ANP-10263Q1NP
Revision 0

**ANP-10263P, Codes and Methods Applicability Report for the
U.S. EPR**

**Response to Request for Additional Information – ANP-10263P
“Codes and Methods Applicability Report for the U.S. EPR” (TAC No. MD2803)**

Figure 2-5a
Steam Generator Axial Economizer

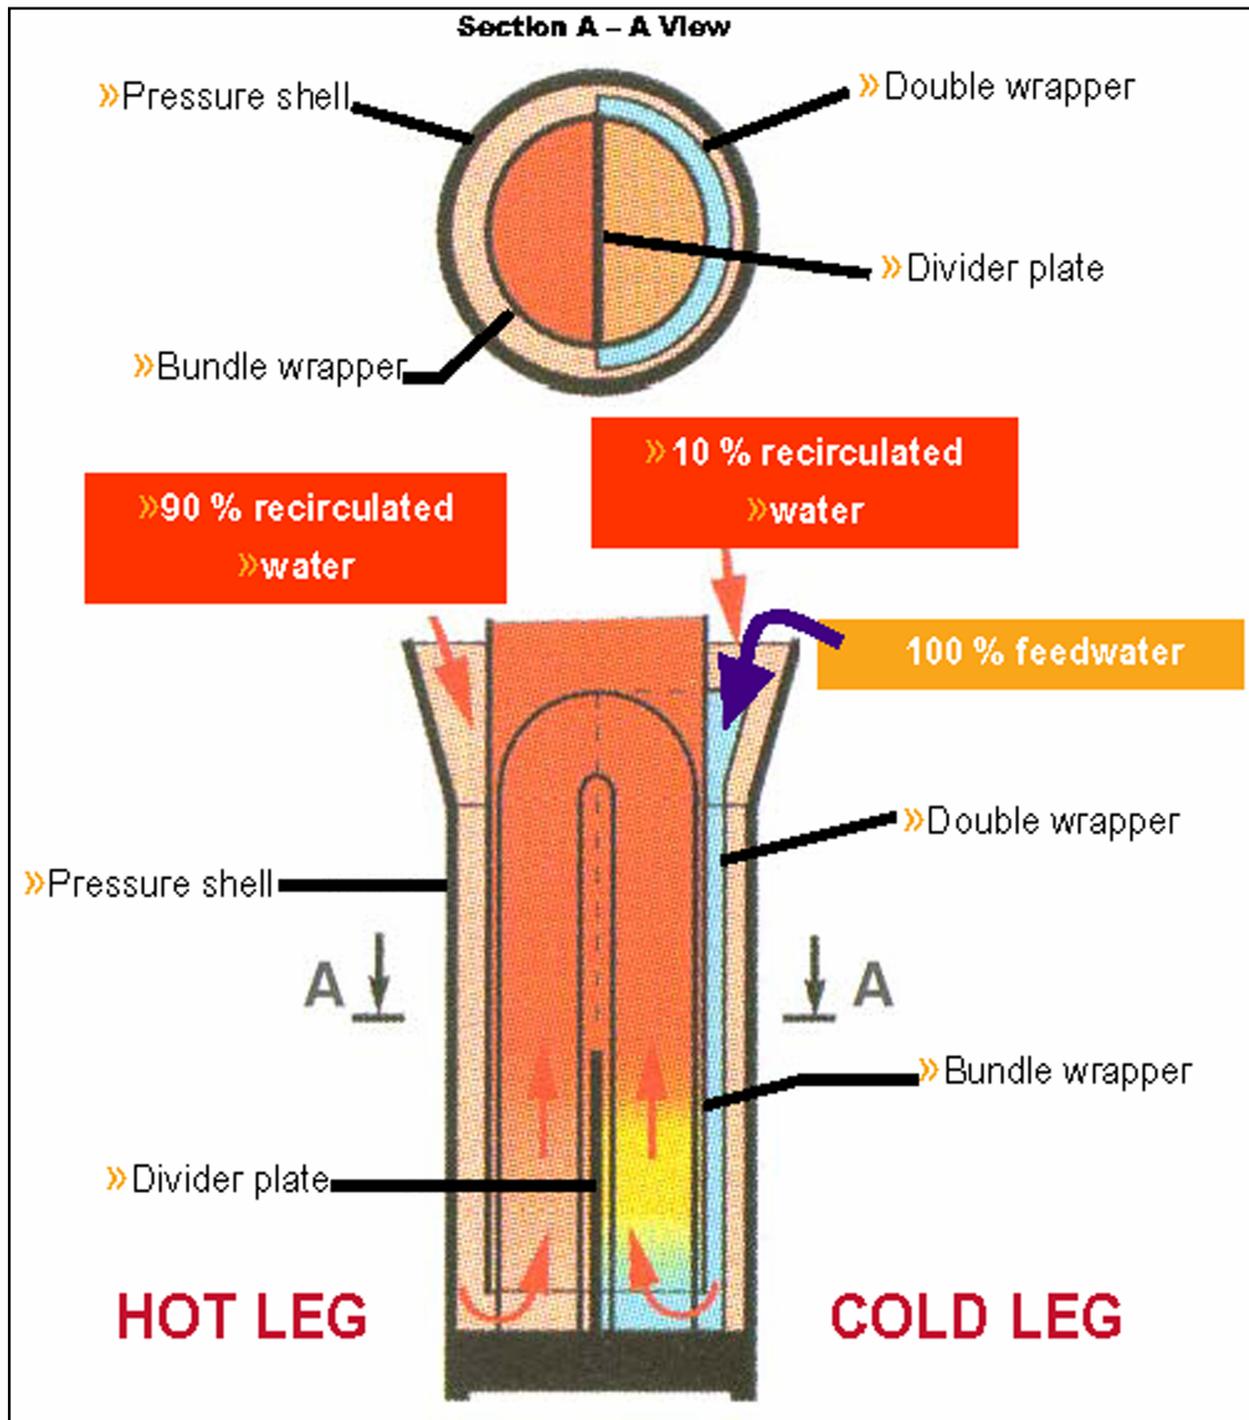
The U.S. EPR SG design includes an economizer, a feedwater preheating section (Figure 2-5 does not appear to show this feature).

RAI 2: *Provide a better pictorial representation of the economizer, both elevation and cross-section views, either replacement or additional figure. On modeling Figure 5-2, provide a cross-section view showing the economizer modeling.*

“Figure 2-5a illustrates the concept and operation of the SG axial economizer.”

The new Figure 2-5a follows this response.

Figure 7-1 MSRT Response

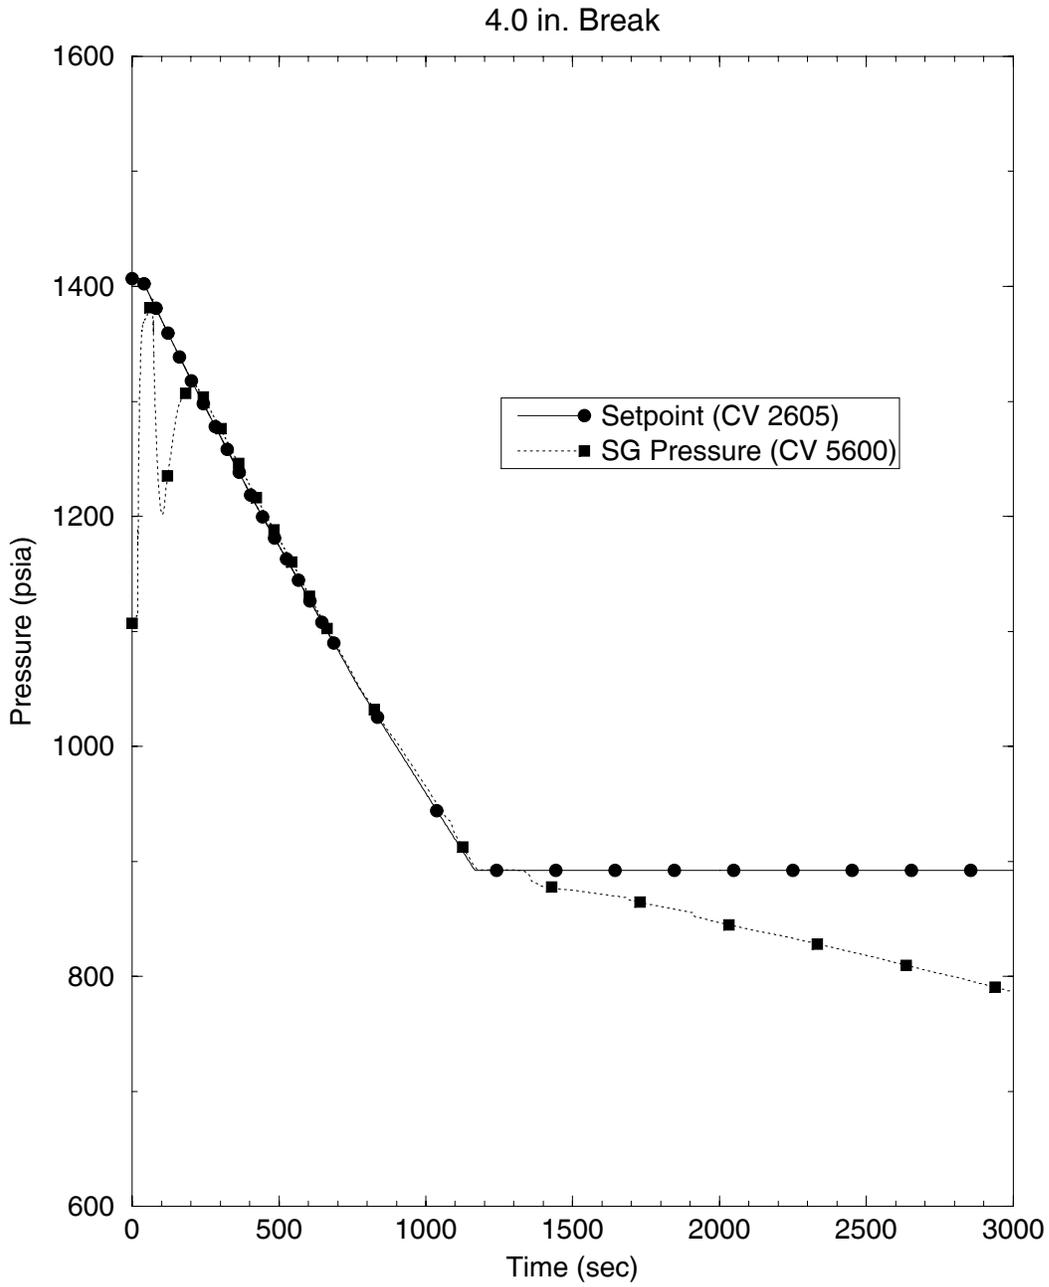
RAI 7: *Section C.2, page C-3: It is not clear where the 1406.9 psia value comes from, the graphical output does not reach this value. The post-trip set-point for the MSRT is not this high. Where does this value come from? Modify the text, or graphical output, according.*

The MSRT system is composed of two valves in series: a normally closed, very fast opening Main Steam Relief Isolation Valve (MSRIV) and a normally open, slow moving motor-operated Main Steam Relief Control Valve (MSRCV). The MSRIV opens when the pressure in the steam generator first exceeds the MSRT control setpoint.

Following a LOCA safety injection signal, the MSRT pressure control setpoint is reduced from nominally 1385.1 psia (+ 21.8 psia uncertainty = 1406.9 psia) to 870 psia (+ 22 psia uncertainty = 892 psia) at a rate corresponding to a reduction in the saturation temperature of 180 °F/h. This reduction in setpoint occurs whether the MSRIV has opened or not. Therefore, depending on the length of time elapsed from the start of cooldown and the rate that secondary pressure rises, the MSRIV may open at a pressure that is much lower than 1385.1 psia. The reduction in pressure control setpoint proceeds independently of actual secondary side pressure.

In the sample problem, SG1 secondary pressure intersects the cooldown curve at 70.8 seconds at a SG1 pressure of 1382 psia and the MSRIV opens. The opening of the valve results in a high flow through the MSRCV (which at that time is 100% open) and a drop in SG pressure of about 120 psia resulting in MSRCV modulating close. The MSRCV modulates open again at 206 seconds at a pressure in SG of 1316.1 psia. From then on the SG pressure follows the cooldown curve. Figure 7-1 presents this behavior for SG1. The other three SGs behave similarly.

Figure 11-1 Detail of Reactor Vessel Inlet Nozzle Region of Downcomer

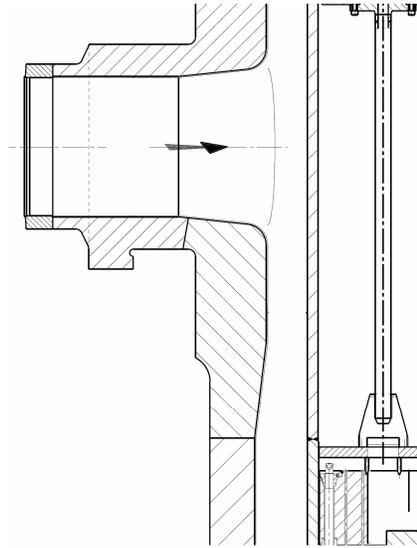
RAI 11: *It is not clear from the text or from Figure 2-4 what is meant by a variable cross-section area in the downcomer. Elaborate and include a discussion of any changes needed to ensure adequate two-dimensional (θ, z) nodalization of the downcomer for licensing analyses.*

Figure 2-4 of ANP-10263P shows a cross sectional view of the reactor vessel. The detail below (Figure 11-1) magnifies the region just below the cold leg inlet nozzle in the downcomer, showing the reactor pressure vessel (RPV) wall and the core barrel. The downcomer annulus is defined by the dimensions of these 2 boundaries.

The cylindrical shell of the RPV consists of two sections, an upper and lower part. To minimize the number of large welds, which reduces the frequency of in-service inspections, the upper part of the RPV is machined from a single forging and fabricated with eight nozzles. Since the nozzles are fabricated into the massive plate used in the RPV shell, most of the reinforcement needed for the nozzle design is provided by the vessel material itself. Therefore, the nozzles used in this design are the “set-on” type requiring a less substantial weld bead than would otherwise be required.

Below the forging in the nozzle region, continuing down to the bottom of the downcomer, the lower RPV wall is thinner, resulting in an increase in the downcomer annular width. This change in the downcomer flow area is captured in the S-RELAP5 model.

The uppermost volume in the lower downcomer spans the transition in the RPV inner diameter from 15.59 ft at the nozzles to 15.98 ft for the lower wall. The flow area of this control volume is calculated based on the actual dimensions of the wall above and below the transition and the distance below the nozzles where the transition in wall thickness occurs. The uppermost volume in the ANNULUS therefore has a smaller flow area than the 3 lower volumes.

Figure 13-1 Primary and Secondary System Pressures for 4 Inch Break

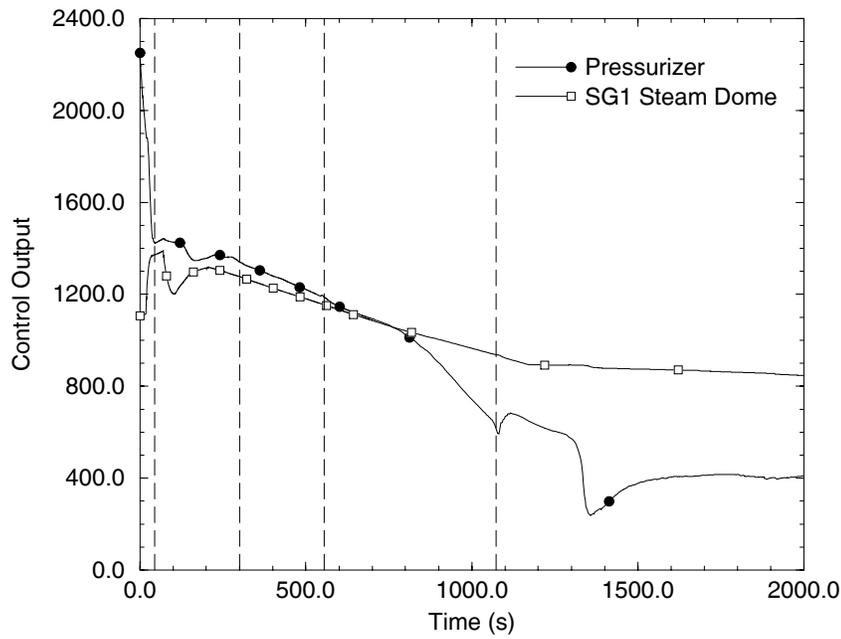
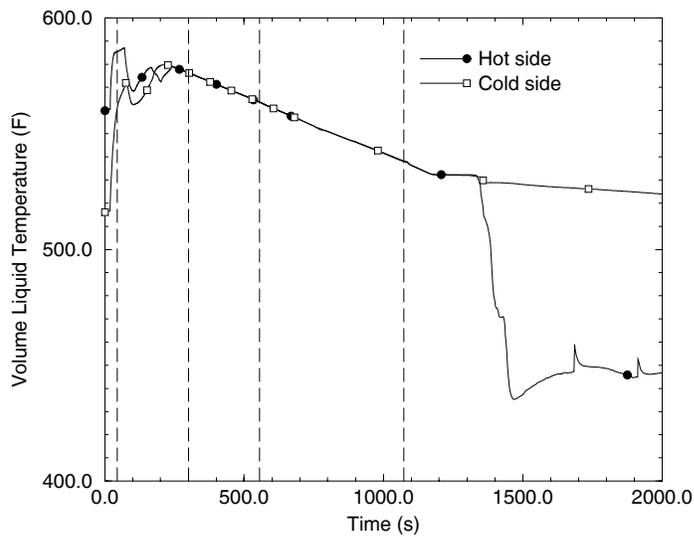
RAI 13: *The referenced benchmarks (Table 4-2) do not specifically address SG mass and heat transfer. Expand the PIRT to specifically address SG mass and heat transfer during all phases, including phenomena associated with reflux condensation. Expand the validation data base for SG mass and heat transfer, including reflux condensation, particularly to address the later phases of the event.*

Figure 13-1 shows the effects of the partial cooldown, which started just after 200 seconds and continues past 1100 seconds. At the end of loop seal clearing, the break flow transitions from low quality two-phase flow to primarily steam flow which causes the primary system to depressurize at an increased rate. The higher depressurization rate of the primary system causes the primary pressure to decrease below the secondary pressure at about 760 seconds. After this time, condensation in the steam generators ceases since the secondary temperature will be superheated with respect to the primary saturation temperature. Except for the decreasing pressures from the partial cooldown, the process is identical to those found in current PWR designs. Since mass transfer and reflux condensation in the steam generator during the boil-off and recovery periods are currently ranked as medium low importance, no change in ranking is warranted. Also, the current assessments are sufficient since no new phenomena are occurring.

The effect of the economizer is to lower the steam generator outlet temperature, which improves the plant efficiency during normal operating conditions. Figure 13-2 shows the calculated temperature histories of the bottom nodes on the hot and cold sides of the economizer. Immediately after break initiation, both temperatures rise in response to the cessation of main feedwater flow and the main turbine stop valve closure. A distinct temperature difference is maintained until 240 seconds. After 240 seconds, the hot and cold side temperatures coincide until the PCT node quenches after 1300 seconds, which is the result of the partial cooldown that was started at approximately 200 seconds. After 240 seconds, the economizer behaves the same as existing PWR designs through the loop seal clearing, boil-off, and recovery periods of a SBLOCA. Since the pumps finally coastdown by 150 seconds, the economizer has no influence during the blowdown period and the first 105 seconds of the natural circulation period. Finally, the only period of influence by the economizer is a small time frame during the natural circulation period. Since natural circulation flow ceases after 300 seconds, the economizer had little influence on flow between 150 seconds and 240 seconds. Consequently, the economizer has no impact on the current steam generator rankings in the Informal SBLOCA PIRT.

Figure 21-1 Heavy Reflector

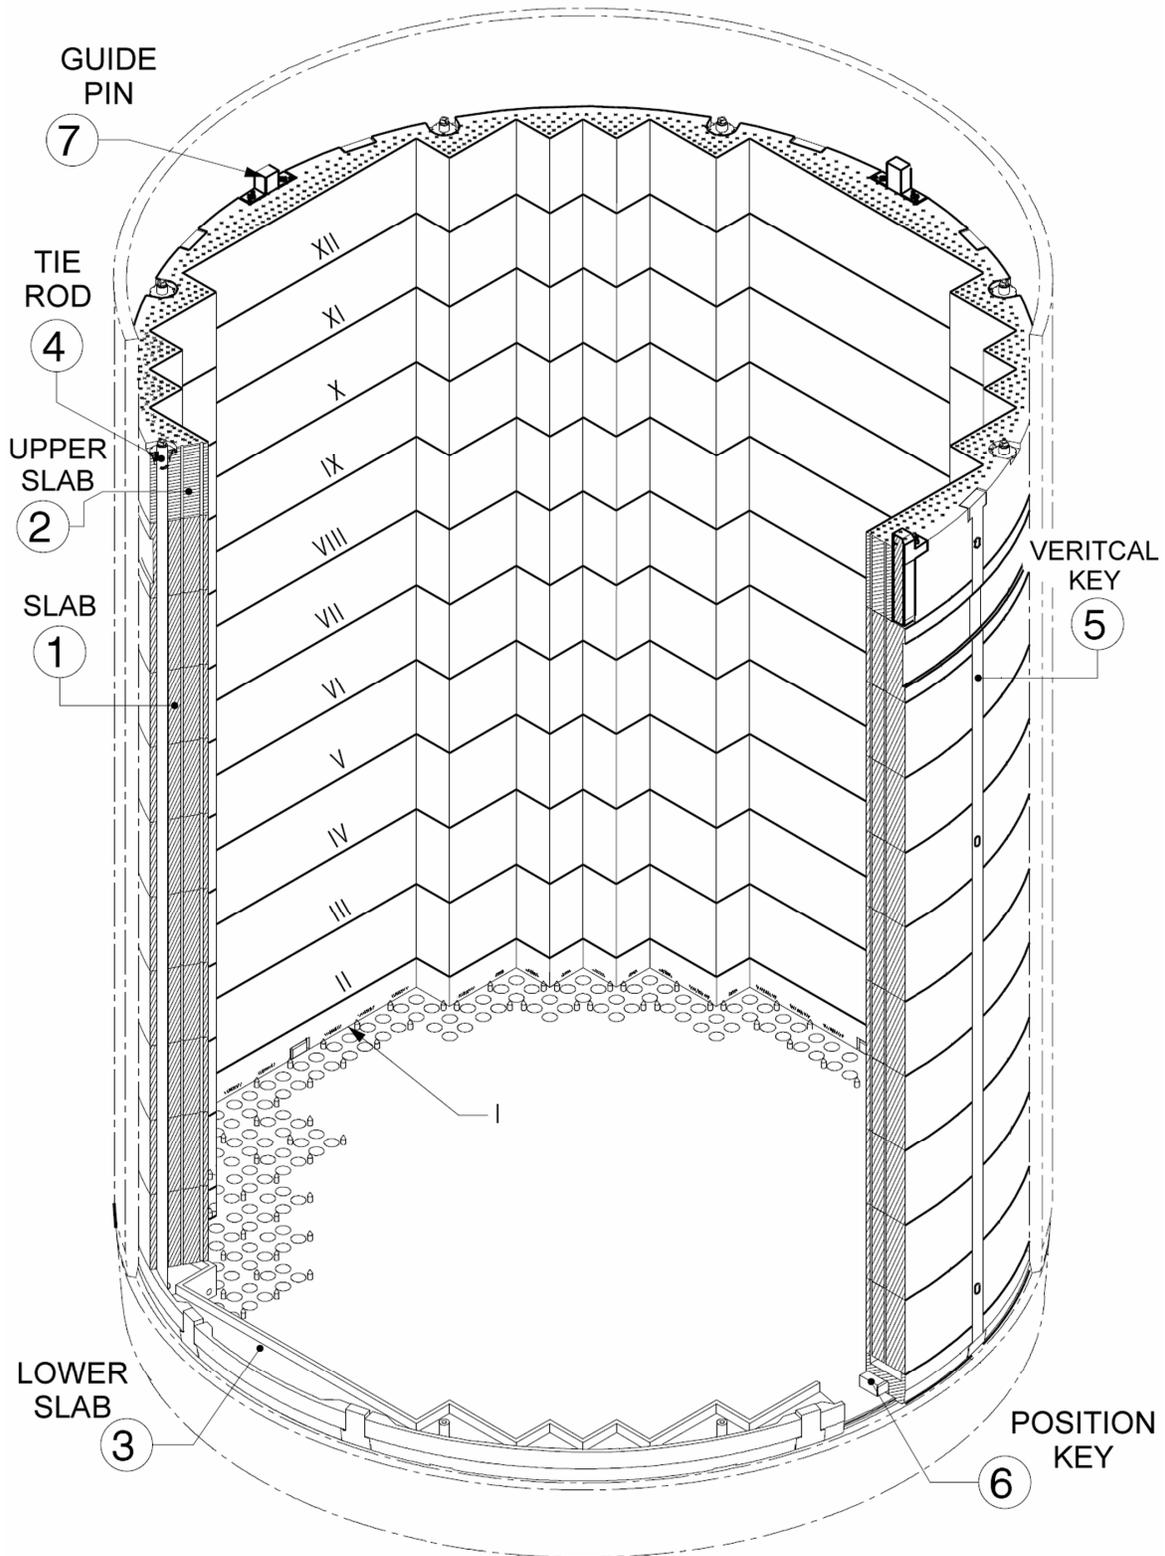
- RAI 21:** a) *Please describe the coolant flow system for these channels (number and size of the channels, and flow path from entrance to exit).*
- b) *Please provide the AREVA plans to validate the flow path modeling. Include a discussion on the entrance/exit loss factors, channel pressure drop, likelihood and consequences of steam binding (or blockage) in some or all channels, and the adequacy of the fluid flow map to model the expected flow pattern in the channels. How does blockage of these channels affect the EPR performance for AOOs, DBAs, LOCAs (large and small) and long term cooling?*

The space between the multi-cornered radial periphery of the reactor core and the cylindrical core barrel is filled with a stainless steel structure, called the heavy reflector, the purpose of which is to reduce fast neutron leakage and flatten the power distribution. The reflector is inside the core barrel above the lower core support plate. To avoid any welded or bolted connections close to the core, the reflector consists of stacked forged slabs (rings) positioned one above the other with keys, and axially restrained by tie rods bolted to the lower core support plate. (See Figure 21-1.)

The heavy reflector is dimensioned to accommodate expansion of the fuel assembly arrangement. Water cooling is provided by means of coolant channels inside the heavy reflector to prevent excessive stress and deflections of the rings due to the heat generated inside this steel structure by absorption of gamma radiation.
